# Access Compliance Report

## Public Rights-of-Way

### (Curb Ramps)

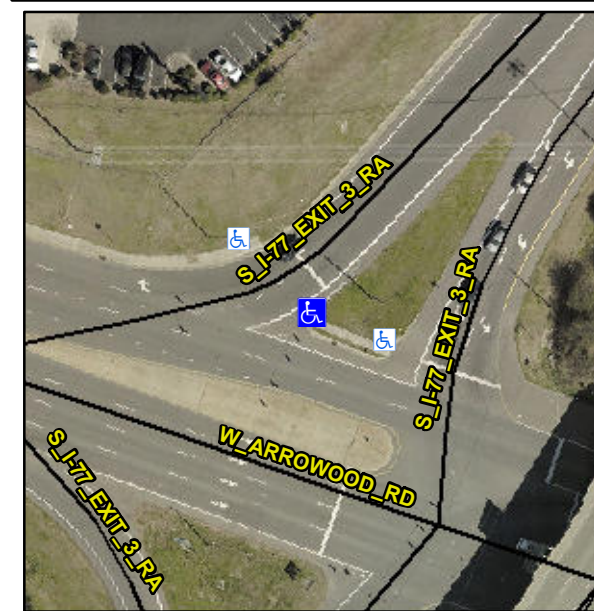
Intersection ID: 43242	Main Street: I-485_RA	Cross Street: S_I-77_HY	Location:	N
ADA ID: 137764194E27	Ramp Type: Perp	Initial Pass/Fail: Fail	Overall Compliance: No	Severity Score: 8.75
Codes/Mitigation Info/Possible Solution		Field Measurements/Component Compliance

**Not Found, R304.5.1**

**Remove & Replace Entire Ramp.**
